NOTICE OF PROPOSED CHANGE IN PROPERTY

Petition: x1482

Public Lighting Authority.
(Utility or City Department)

B	DESCRIPTION	DATE	BY
A	DESCRIPTION	DATE	BY
DRAWN BY: WLW		DATE: 06-05-17	APPROVED:
JOB NO. 01-01		DRWG. NO. X 1482	
CITY OF DETROIT CITY ENGINEERING DEPARTMENT SURVEY BUREAU		REQUEST TO CONVERT TO EASEMENT THE EASTWEST AND NORTHSOUTH PUBLIC ALLEYS, 20 FT. WD. IN THE BLOCK BOUND BY LEDYARD, HENRY ST., CASS AVE. AND SECOND BLVD.

X 1182

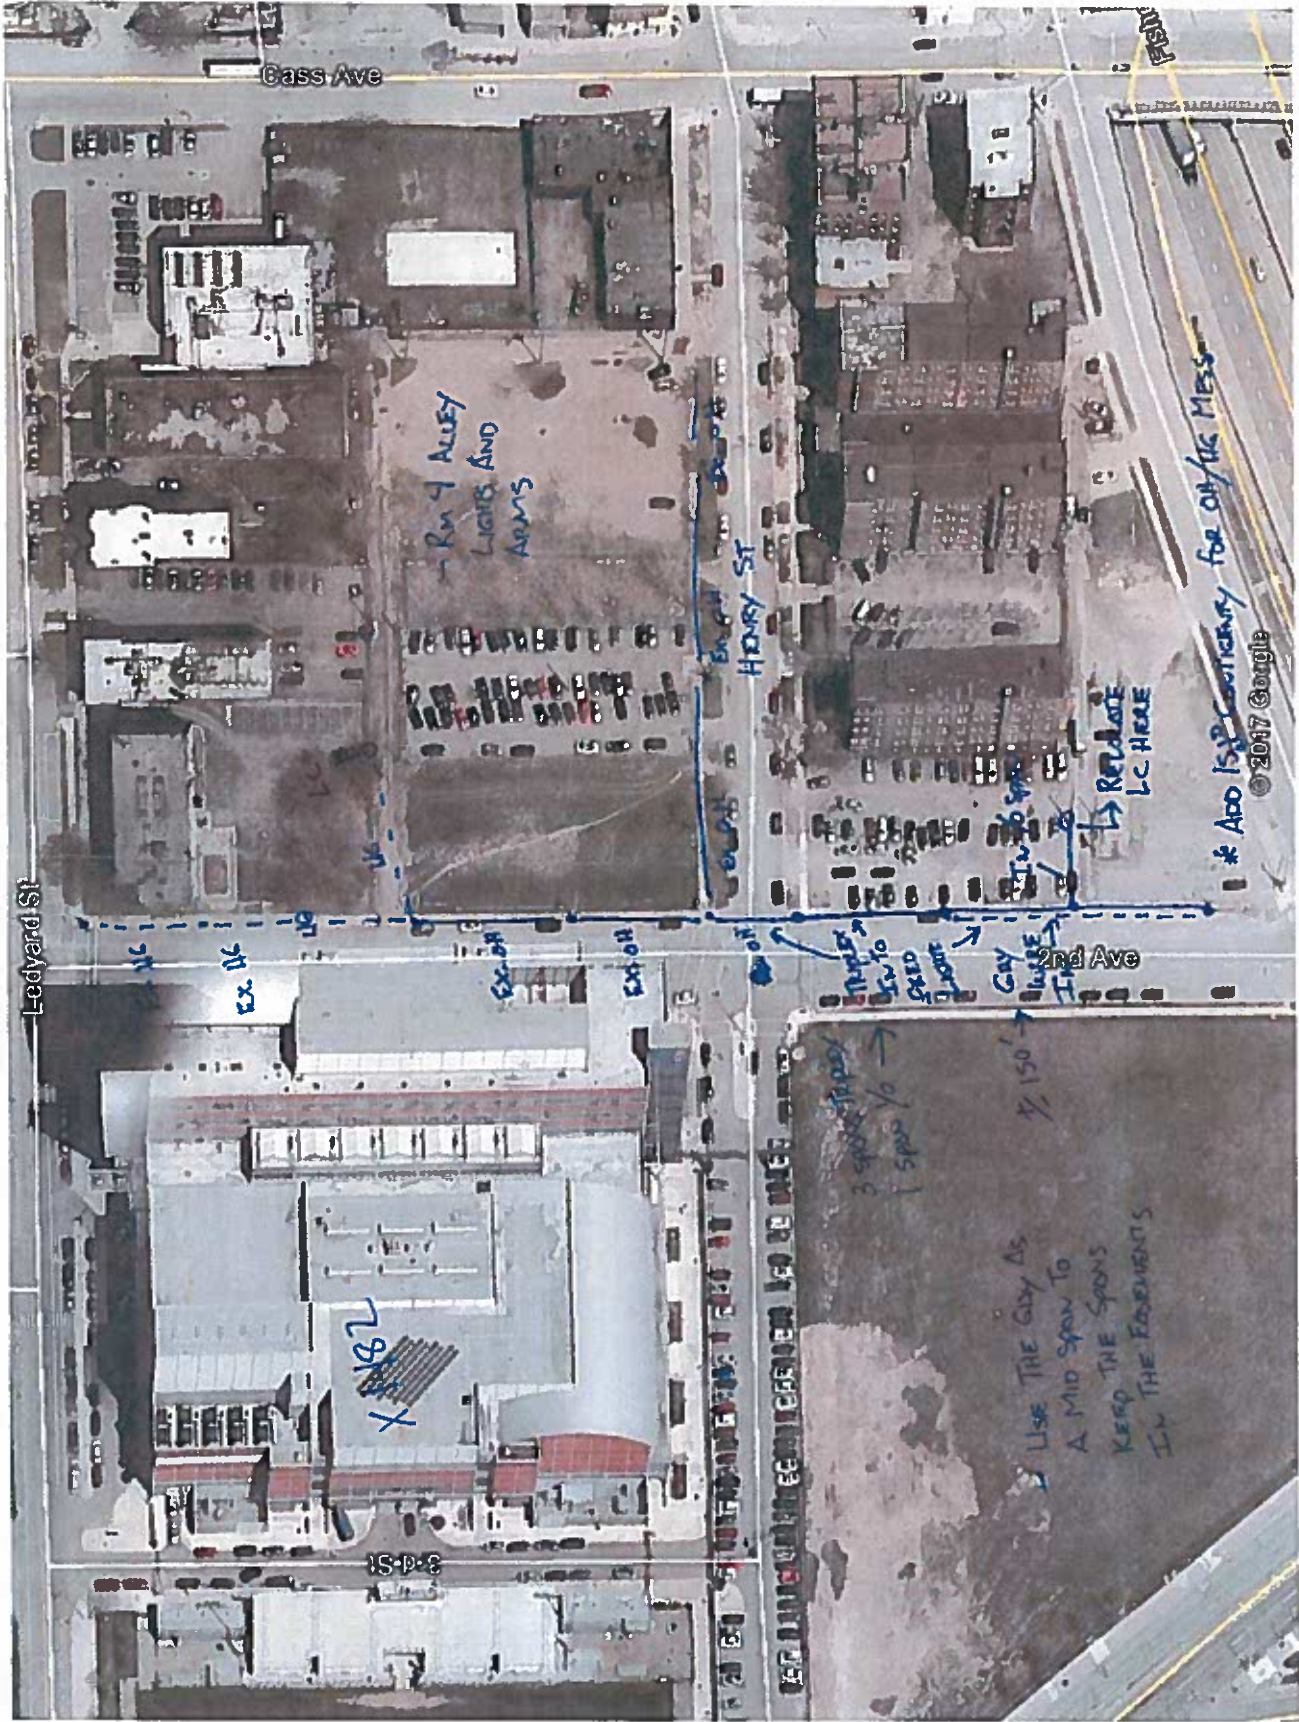
Run 4 ALLEY LIGHTS AND ARMS

RELOCATE LC HERE

* Add 150' temporary for on the mess

USE THE GUY AS A MID SPAN TO KEEP THE SPONS IN THE EQUIPMENTS

THUNDER GUY TO SPEED LIGHTS

GUY W/BLADE TIE
